Our Ref: PSM5077-002L

7 December 2023

RE: HILLS OF GOLD WIND FARM-INDEPENDENT EXPERT ADVICE ON CONSTRUCTABILITY, SOIL AND WATER

Inset 3: Charts showing assessed existing terrain slopes at the proposed WTG locations

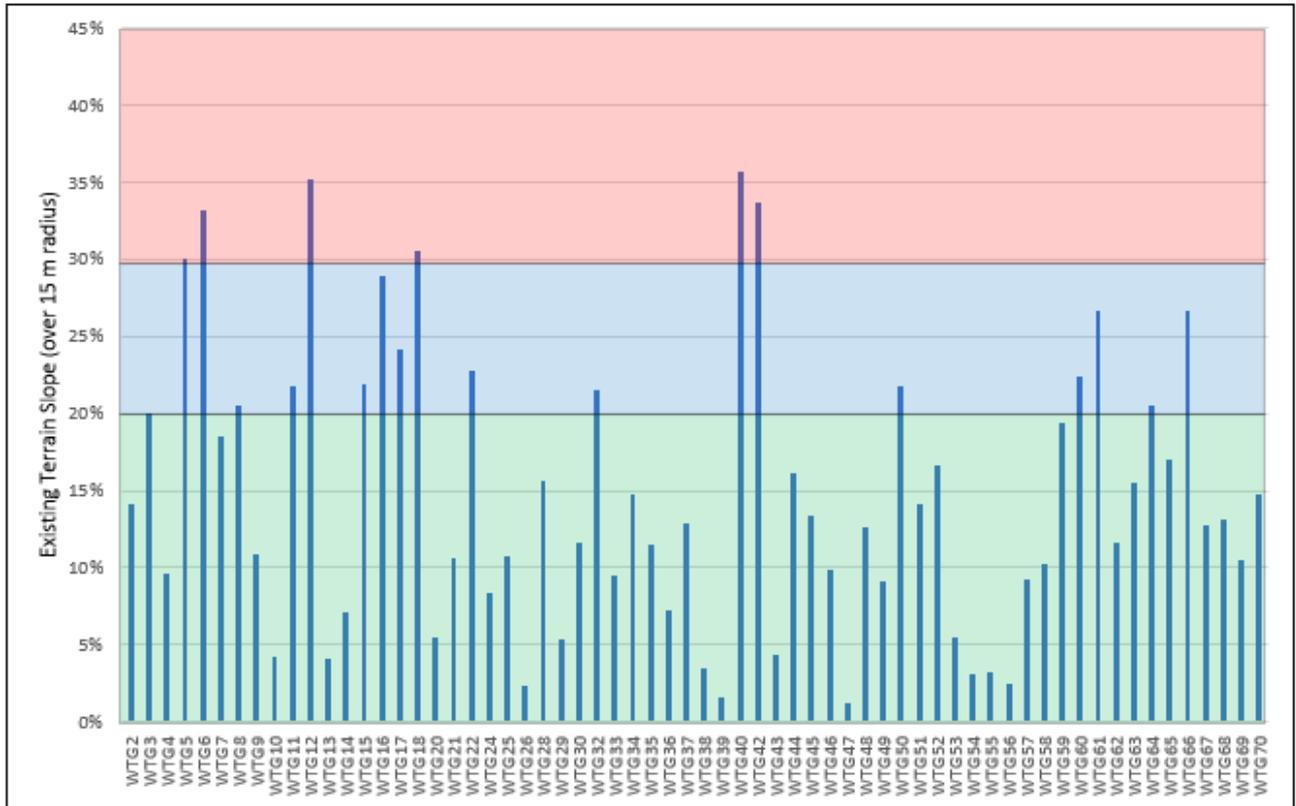
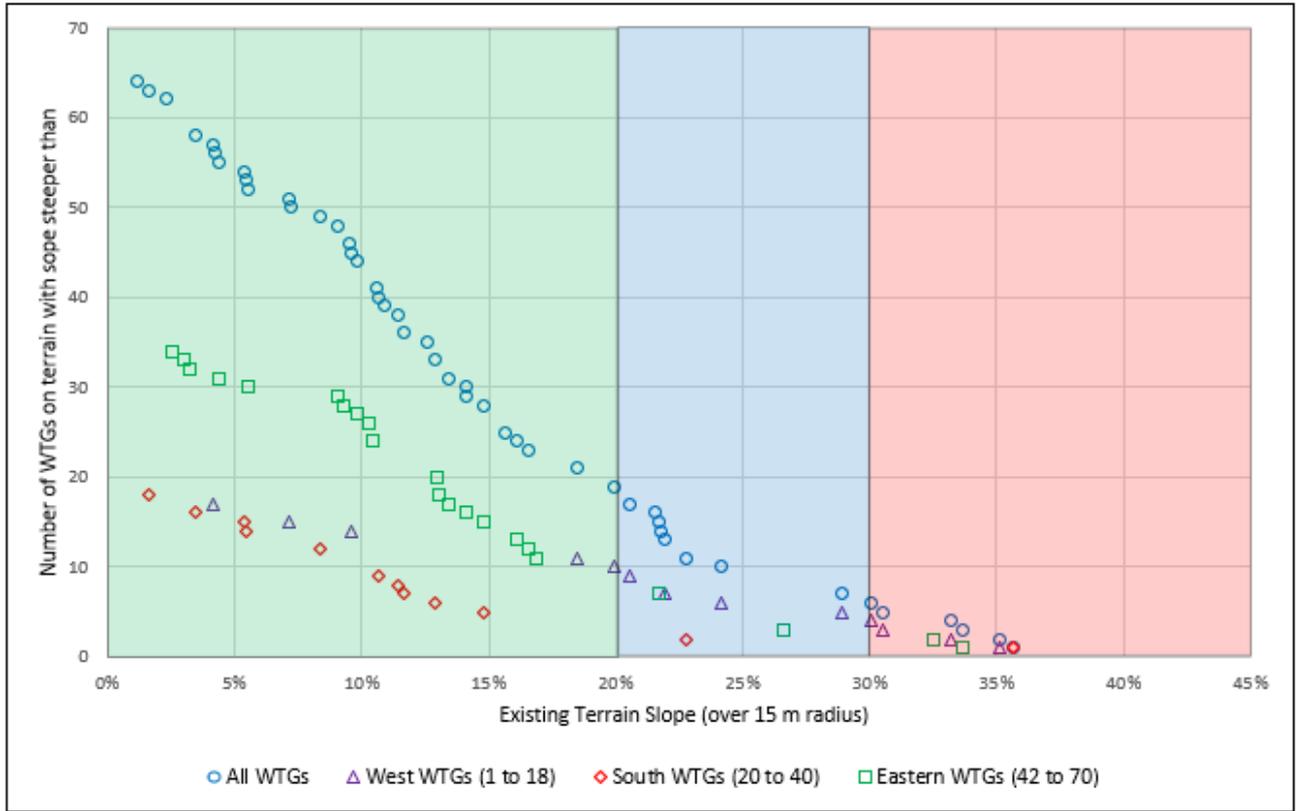
17 of the 64 WTGs (i.e. 27%) occur in terrain with existing slope greater than 20% and 5 of the 64 WTGs (i.e. 8%) occur in terrain steeper than 30%.

Inset 4: Schematics showing details of WTG foundation excavation geometry for varying slope terrains

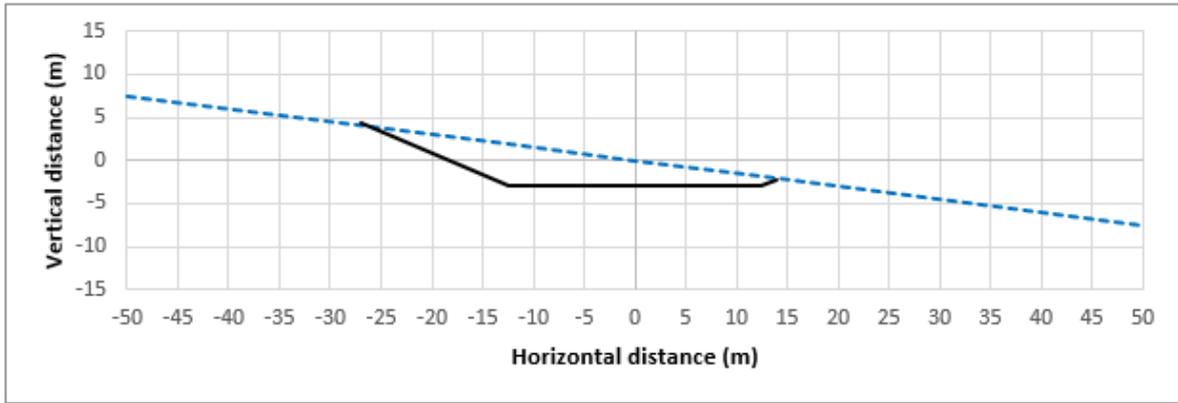
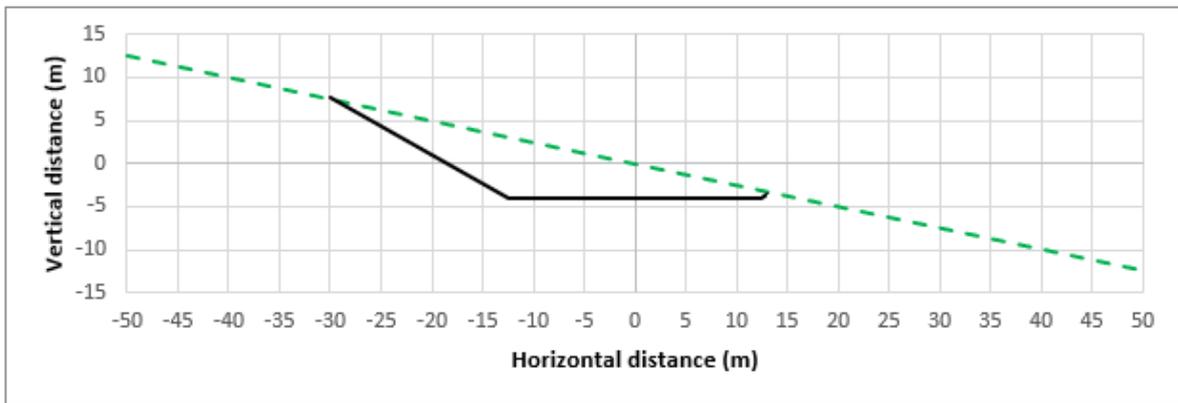
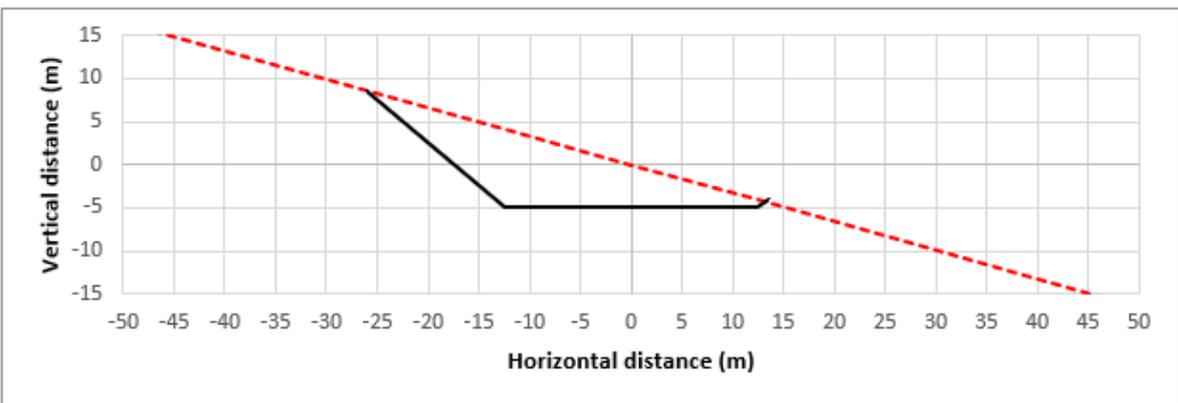
From these we note that:

- Where terrain slopes are less than 20%:
 - Minor excavation and filling is required for both the foundations and the hardstand areas
 - Typical cut and fill batter heights are less than 5 m

- Batter slopes of 2H:1V or flatter without support should be stable, with batter lengths typically less than 12 m
 - The proposed erosion mitigation measures, including progressive rehabilitation are expected to work well in these areas.

- Where slopes terrains are greater than 25% (and in some case above 33%):
 - Excavation and filling required to construct the foundation and hardstand areas increase substantially

- With regards to the WTGs foundations, the cuts are temporary and likely to be in stronger rock. Thus, well designed and constructed works are likely to be able to limit the size of the excavations and to control erosion and runoff during this temporary stage

Inset 5: Schematics showing details of WTG hardstand area geometry for varying slope terrains

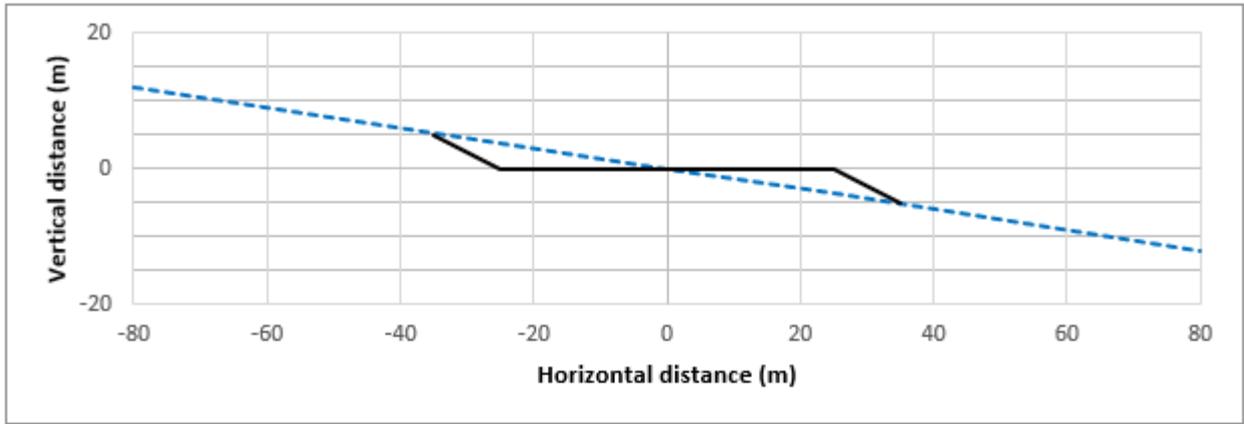
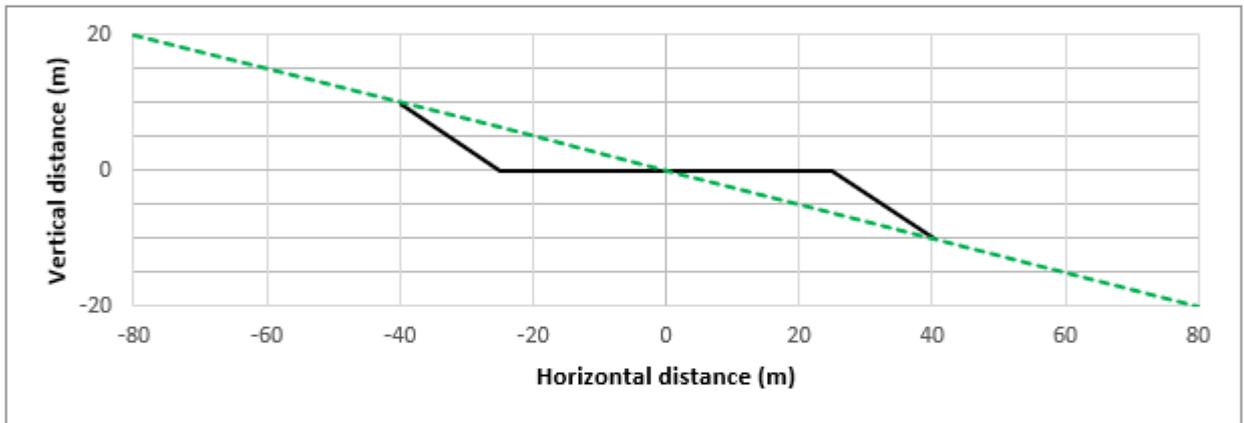
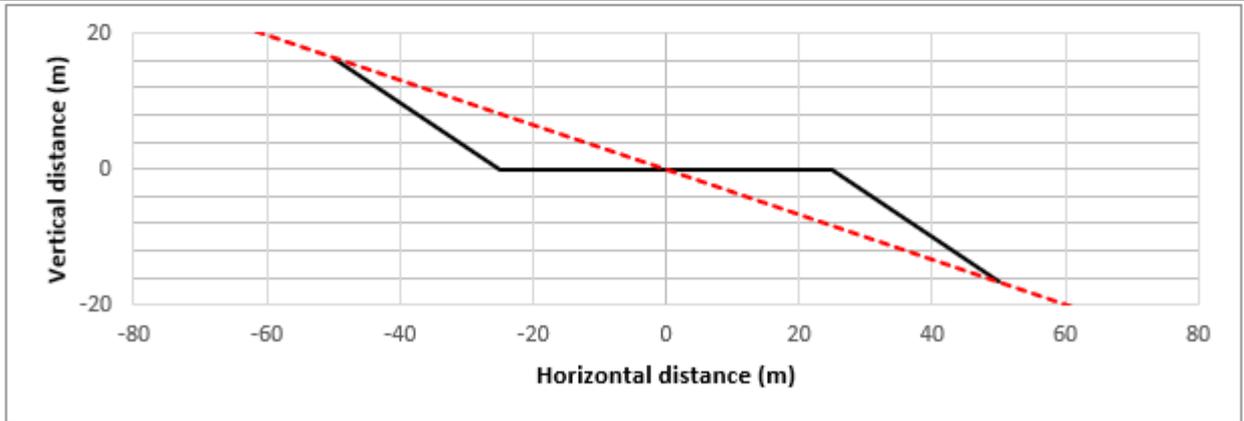
- With regards to the hardstand areas, cut and batter slopes steeper than 2H:1V will be required to control the footprint of the works and cut and fill batter heights typically greater than 10 m will be required resulting in slope lengths of 20 m to 30 m. Careful locating of the hardstand area at detailed design stage can be used to mitigate some of these effects

- The hardstand areas are permanent and the typical erosion mitigation measures described in the EIS are unlikely to work in these areas. The use of retaining structures or select material (e.g. rockfill) is likely to be required to achieve the steeper batter slopes in fill. Progressive rehabilitation of steeper fill slopes will require specialised tools, and larger surface areas are likely to be susceptible to erosion and runoff for longer periods of time until the vegetation is established.

Inset 6: Charts showing assessed existing terrain slopes at Access Track locations

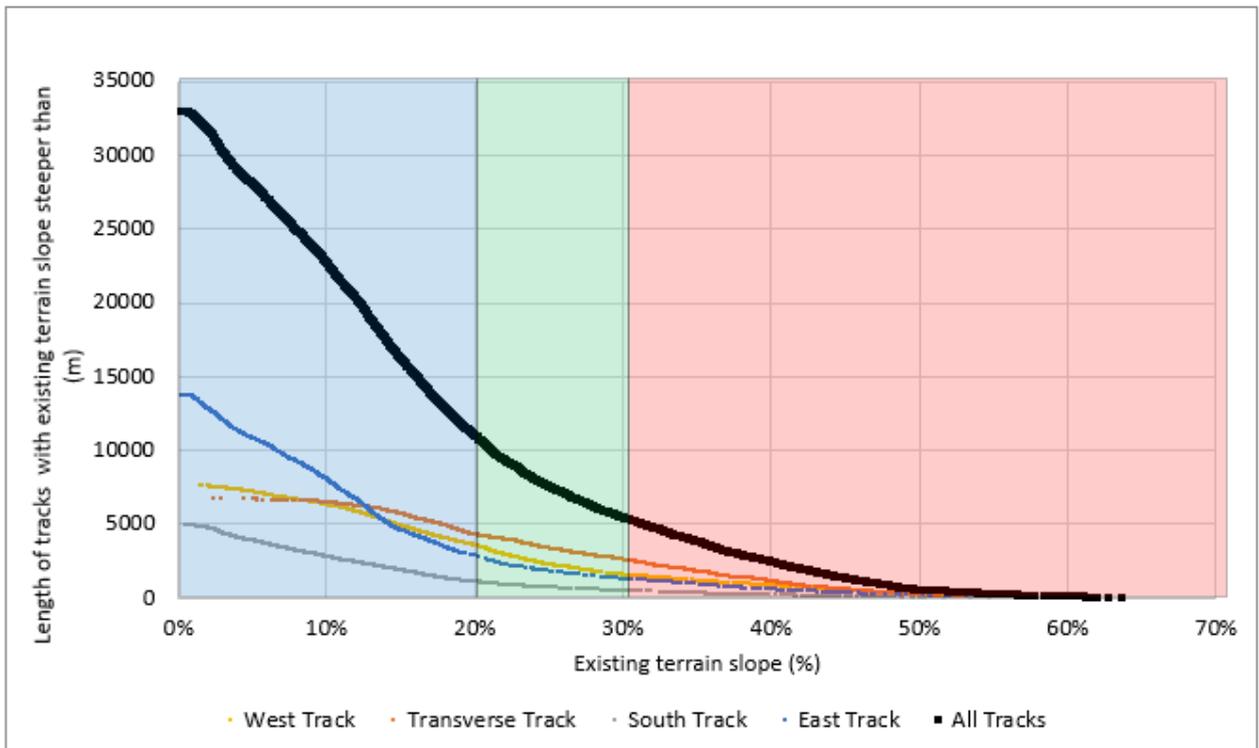
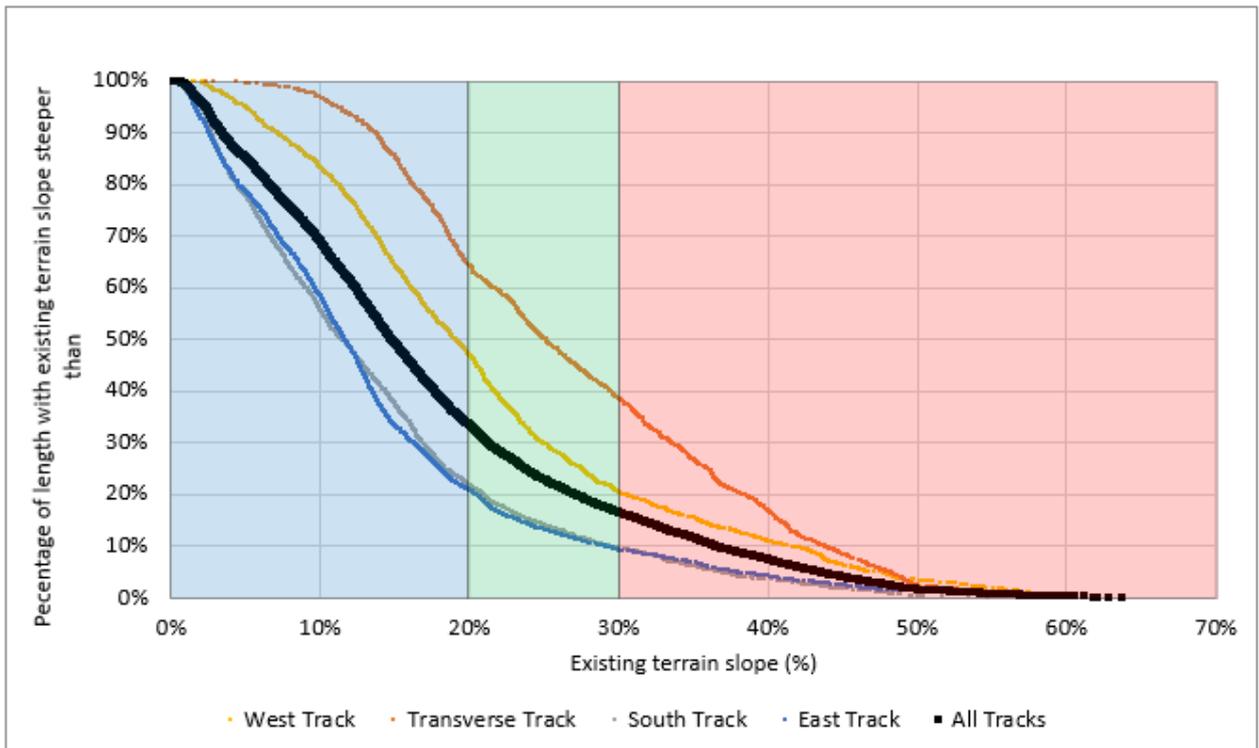
- Approximately 33% of the Access Tracks (equivalent to approximately 10 km) are located in areas where the existing terrain slope is steeper than 20% and present at least high erosion potential as assessed by the EIS
- Approximately 17% of the Access Tracks (equivalent to approximately 5 km) are located in areas where the existing terrain slope is steeper than 30% and present at very high erosion potential as assessed by the EIS

- There is approximately 15 km of Access Tracks that occur in areas where the EIS itself indicates at least high erosion potential requiring specialised erosion and surface water control mitigation measures
- Over 60% of the TT traverses areas where the existing terrain slope is steeper than 20%
- 40% of this track traverses areas where the existing terrain slope is between 30% and 50%
- The TT crosses a number of more deeply incised drainage paths
- The South Track and East Tracks are located along the ridgeline and the terrain slopes are significantly flatter.

Inset 8: Schematics showing details access track cut and fill geometry for varying slope terrains, where roads are constructed at grade (for steep terrain)

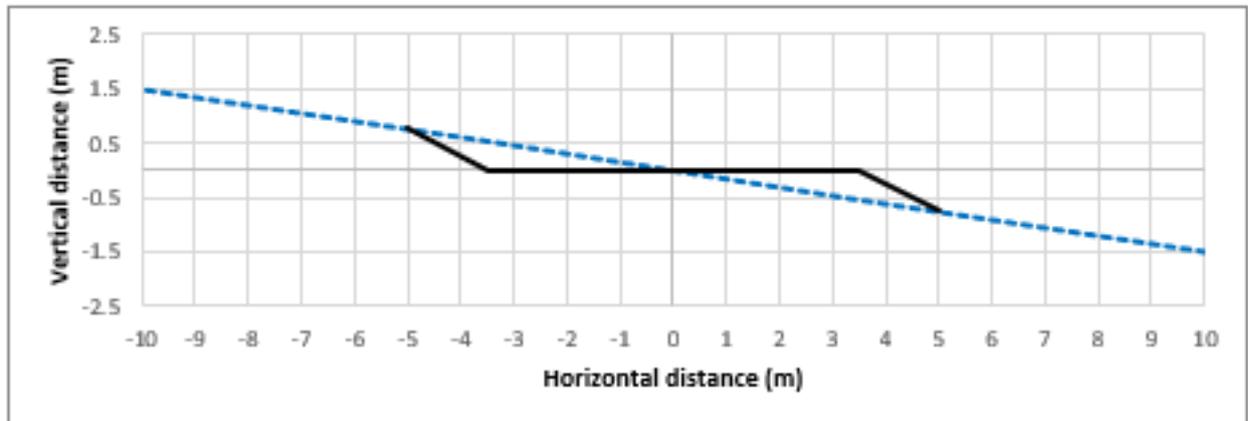
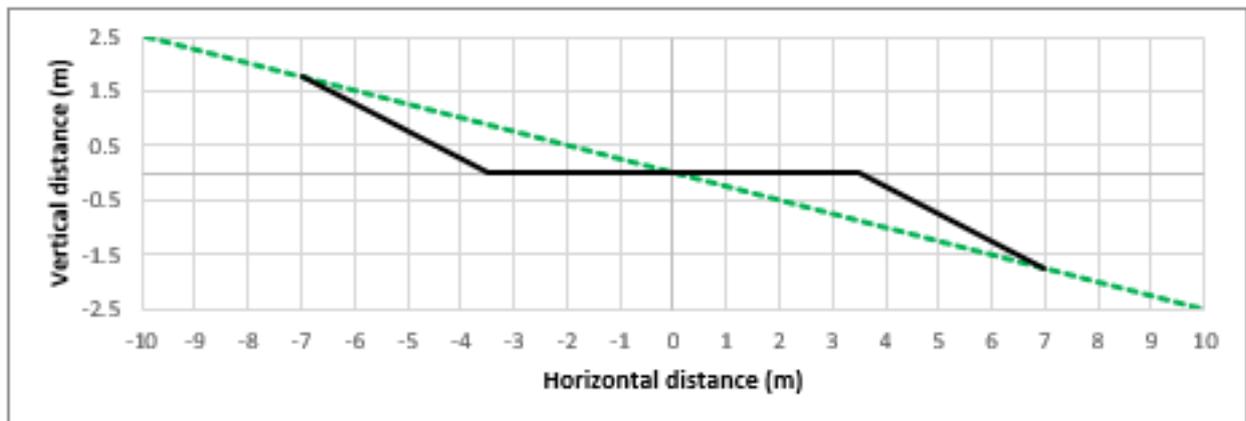
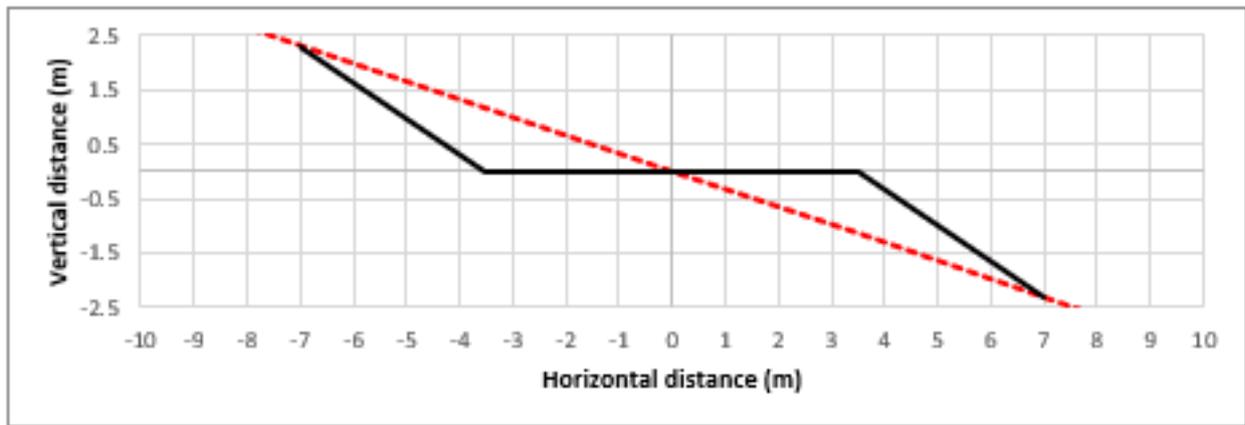
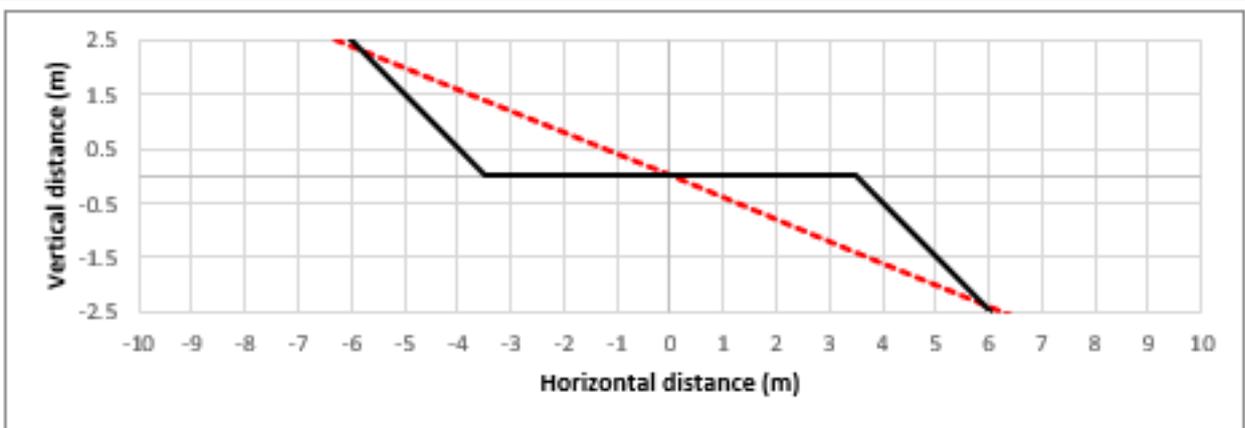
From these we note that:

- Where terrain slopes are less than 25%, minor excavation and filling will be required for the Access Tracks. Typical cut and fill batter heights are less than 1.0 m. Batter slopes of 2H:1V or flatter can be made to work, with batter lengths typically less than 2 m. The proposed erosion mitigation measures, including progressive rehabilitation are expected to work well in these areas. This represents over 80% of the Access Tracks alignment

- Where slopes terrains are greater than 25% (and in some case up to 40%), the challenges associated with excavation and filling required to construct the Access Tracks increase, namely:

- Cut and batter slopes steeper than 2H:1V will be required to control the footprint of the works. The use of retaining structures or select material (e.g. rockfill) is likely to be required to achieve the steeper batter slopes in fill

- The thickness of the fill and height of the cuts are typically less than 2 m, however, can result in slope length of 3 m to 5 m depending on the adopted batter angles

- Progressive rehabilitation of steeper fill slopes will require specialised tools, and larger surface areas are likely to be susceptible to erosion and runoff for longer periods of time until the vegetation is established.

Inset 9: Schematic plan and long section along southern half of TT

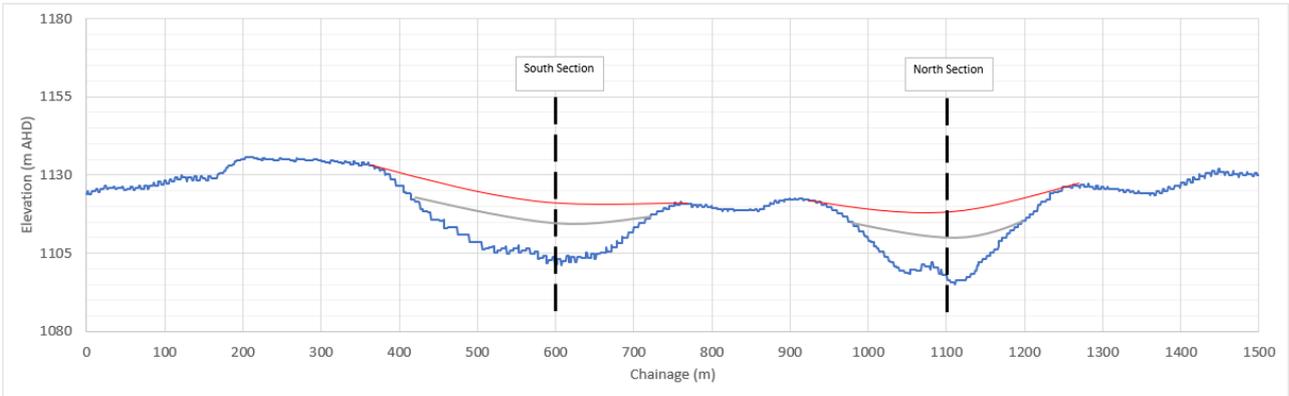
In Inset 9, we have looked at more detail at the two locations where the TT crosses the more deeply incised drainage paths. A schematic long section of the TT over two such drainage paths are shown below. We have inferred in the red and the grey two potential road alignment over these drainage paths.
